UNITED STATES PATENT AND TRADEMARK OFFICE

APPLICATION NO.	FILING DATE	FIRST NAMED INVENTOR	ATTORNEY DOCKET NO.	CONFIRMATION NO.
10/602,345	06/23/2003	Andres F. Zuluaga	12258-029001	1603

Office Action Summary	Application No.	Applicant(s)	
	10/602,345	ZULUAGA ET AL.	
	Examiner	Art Unit	
	Parikha Solanki	3737

(Source: Moreno et al, US Pub No. 2001/0047137)

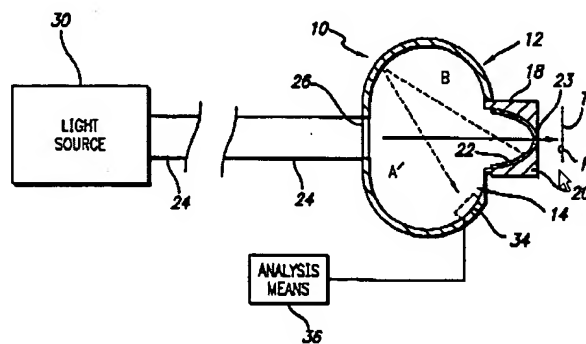
Regarding claim 2, Moreno ('137) shows a jacket encasing the optical fiber(s) (Figure 15).

(Source: Moreno et al, US Pub No. 2001/0047137)

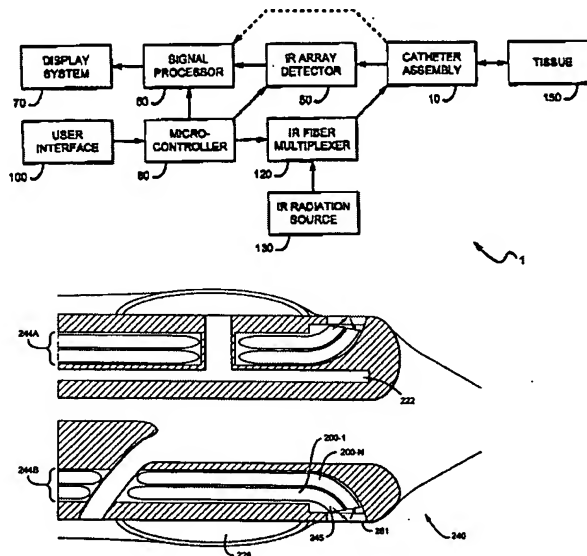
Regarding claims 10-11, Moreno ('137) discloses an atraumatic coupler comprising a lens mounted on the distal end of the fiber-optic probe (Figure 1).

(Source: Casscells ('071), Figures 1 & 20c)

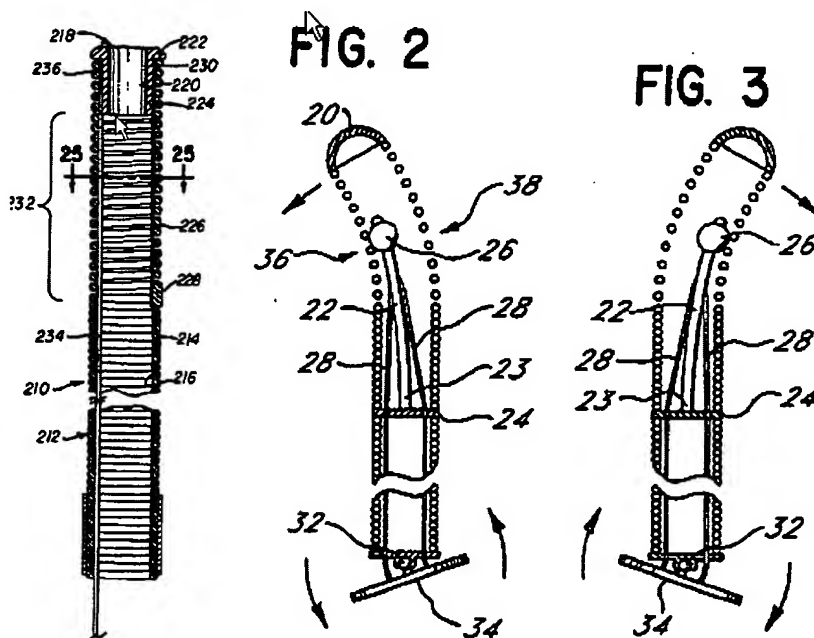
Regarding claim 46, Casscells ('071) discloses a probe having an optical fiber extending therethrough, a means for atraumatically contacting and optically communicating with the intraluminal wall, a light source in optical communication with the fiber for illumination, and a detector in optical communication with the fiber (Figs 1 & 20c).

(Source: Derbin ('021) Figure 4a)

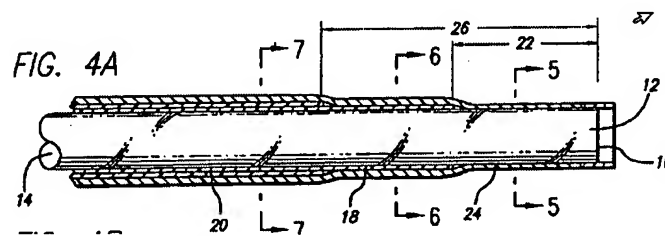
18. Claim 4 is rejected under 35 U.S.C. 103(a) as being unpatentable over Moreno ('173) in view of Hammerslag ('587) as applied to claim 3 above, and further in view of Derbin ('021). Derbin ('021) teaches the use of a variable-thickness catheter shaft in order to provide variations in stiffness along the length of the catheter, more specifically to make the distal tip more flexible than the rest of the body (Fig 4A).

(Source: Kittrell ('010) Figure 13)

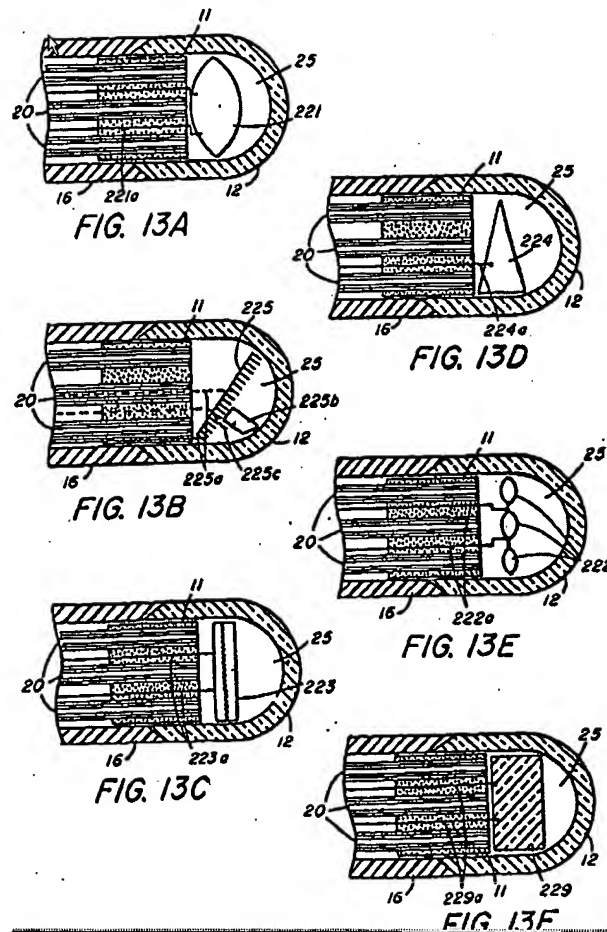
20. Claims 47-49 are rejected under 35 U.S.C. 103(a) as being unpatentable over Casscells ('071) in view of Kittrell ('010). Casscells ('071) discloses all limitations of claim 46 as described above. Casscells ('071) does not disclose a rounded distal tip or contacting the intraluminal wall. Kittrell ('010) discloses a rounded distal tip, and further discloses a lens and diffraction grating to be used at the point of illumination to better control the direction of the illuminating light (Figs 13A & 13B). Therefore, it would have been obvious to one of ordinary skill in the art at the time of invention to modify the probe of Casscells ('071) to further include a rounded surface that may also include a lens or diffraction grating to better control the direction of the illuminating light emitted by the probe assembly, in view of the teachings of Kittrell ('010).
